UTILITY SERIAL NUMBER	PATENT DATE <b>JAN 27 1998</b>	PATENT NUMBER
SERIAL NUMBER 08/433,623	FILING DATE 05/03/95	CLASS 156
	SUBCLASS 643,1	GROUP ART UNIT
		EXAMINER A. HIGGINS

TITLE PROCESS OPTIMIZATION IN GAS PHASE DRY ETCHING

Applicant submits new figures 1-12, consisting of eight sheets of formal drawings. Newly submitted figures correct some inadvertent errors in the originally submitted formal drawings. Amendments to the originally submitted informal figures have been highlighted in red ink.

FIG. 12

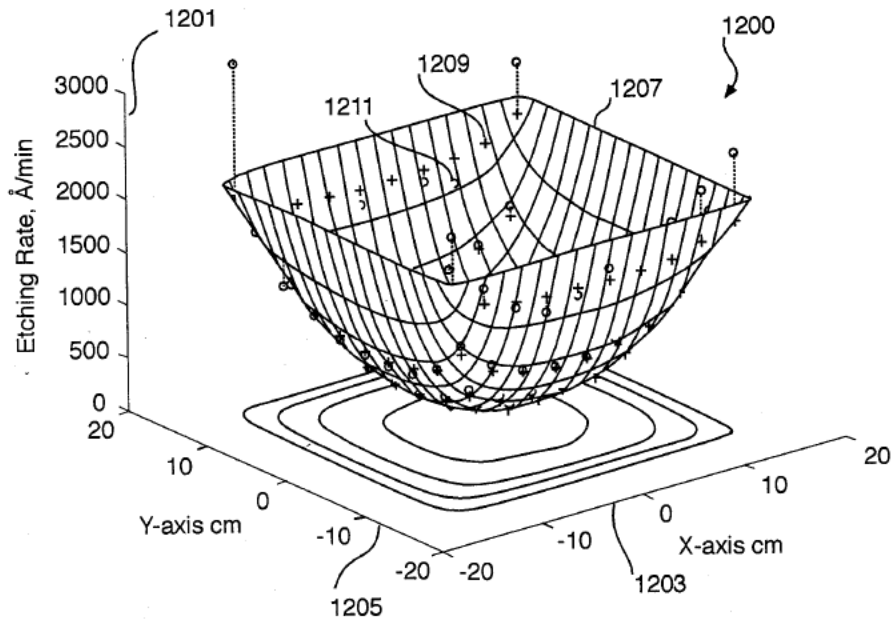
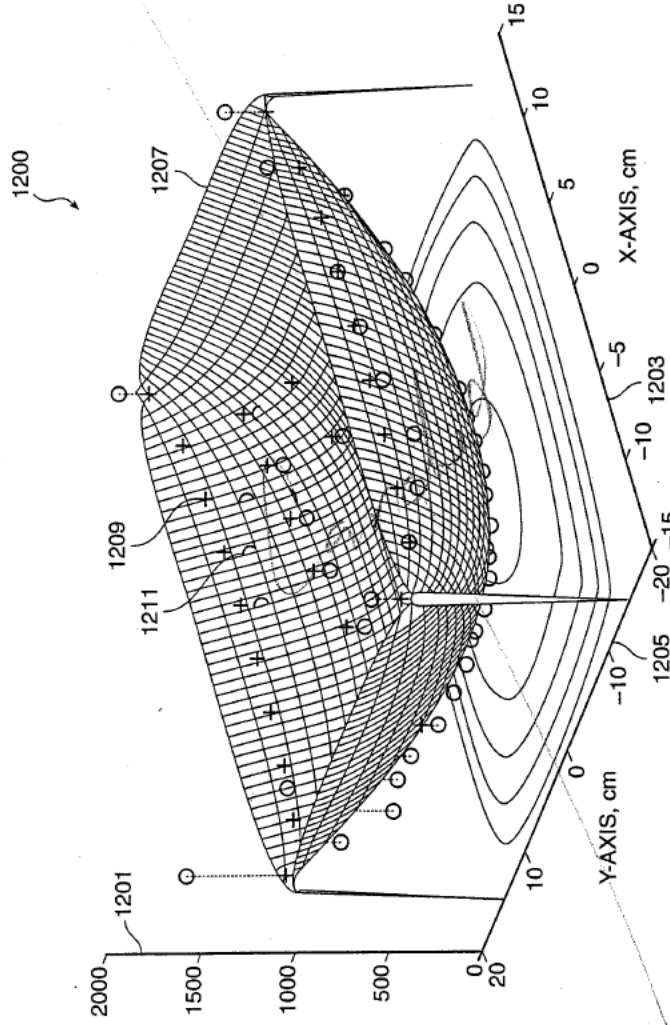
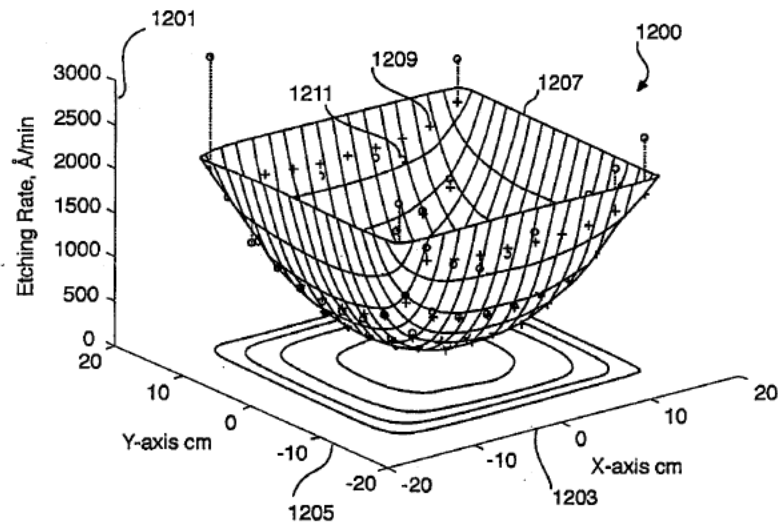
In Fig. 12, the units on the y-axis are changed. Also, the downward spikes at the four corners of the informal drawing are deleted.

In Fig. 12, the units shown on the y-axis of the newly submitted formal drawing are twice as great as the units shown in the original informal drawing. This amendment corrects a typographical error made when making the original drawing. While Applicant believes that those skilled in the art would understand the invention and the error in Fig. 12, this correction is made to avoid any possible confusion on the part of the reader. Also, the downward spikes at the four corners of the informal drawing are absent in the formal drawing. These spikes were the result of utilizing a limited number of mathematical terms to generate the plotted surface. The gridded pattern shown in the formal drawing has no spikes, for example, in accordance with the complete equation in the Specification at page 24, after line 10, and the text at page 26, lines 1-4.
